SERVICE DIRECTIVE BULLETIN NO. 0051

Subject: Main Rotor Transmission Mounting Hardware

Models: All

FIGURE 1

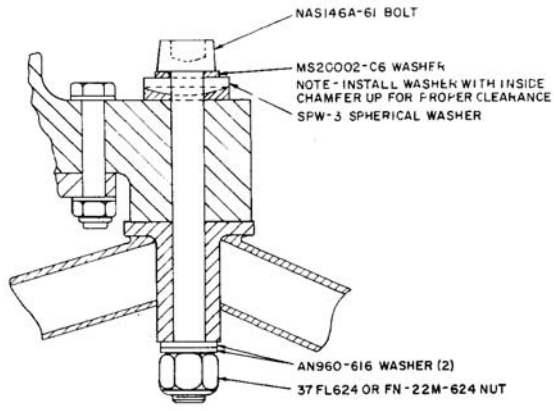
1. Main rotor transmission S/N 42-006-76PS and below, which have not been previously machine spot faced on the upper side of the mounting pad, as shown in fig. 2, have previously been retrofitted with bolts and hardware installed as called for in Service Information Letter No. 0057. The Service Information Letter No. 0057 configuration is to be modified by removing the cotter pin and nut (P/N AN 310-6) from each mounting bolt and replacing with either nut P/N 37 FL 624 or FN-22M-624. Refer to figure 1.

RETENTION BOLT INSTALLATION SHOWING
 ACCEPTABLE WASHER CONFIGURATIONS

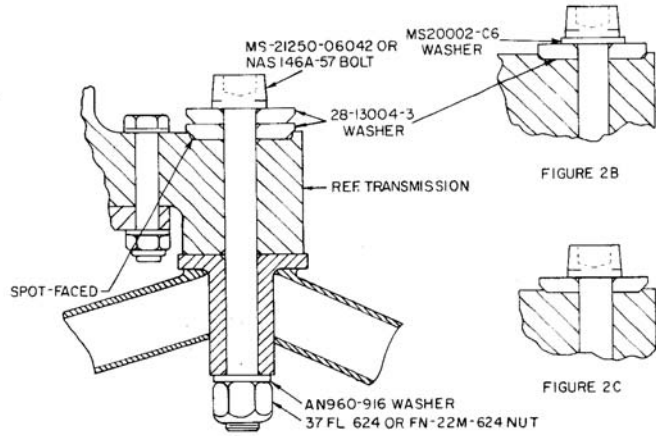
2. Main rotor transmission S/N 42-007-76PS through S/N 46-182-79C, have spot faced mounting pads. These transmissions may require a variety of washers as the dimension of the mounting pad thickness may vary. Acceptable bolt installation and spacing is shown in figure 2, parts A, B, and C. Because of the potential interference of a pylon tube, the left aft mounting bolt may require shimming under the bolt head and chamfered washer.

NOTE: Care must be taken that only a chamfered washer be placed under the head of the bolt and required shims of “AN” washers to complete spacing be placed between the chamfered washer and the transmission lug. The part number for these washers are also called out in figure A and B.

TYPICAL GEAR BOX TO PYLON ATTACHMENT

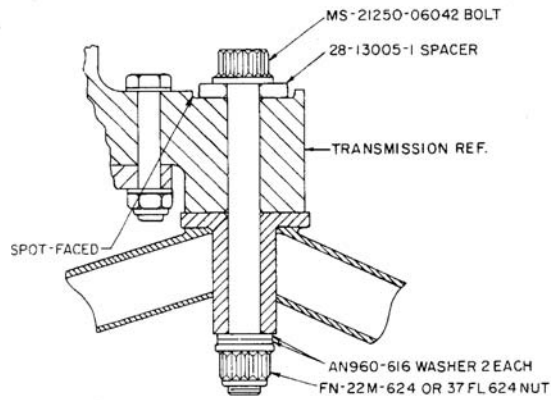
3. Main rotor transmissions S/N 46-182-79C and up, have spot faced mounting pads of a controlled dimension and mounting bolts have been installed per figure 3. No change is required. This configuration of bolt and nut is satisfactory for all prior transmission serial numbers provided that the self aligning washer configuration of Service Information Letter 0057 is used with non-spot faced transmission mount as shown in figure 1 and the proper spacing of figure 2 is maintained with spot faced transmission mounts.

NOTE: The 12 point 7/16” wrench may have to be ground slightly thinner to accommodate wrench removal from the aft left mount after installation.
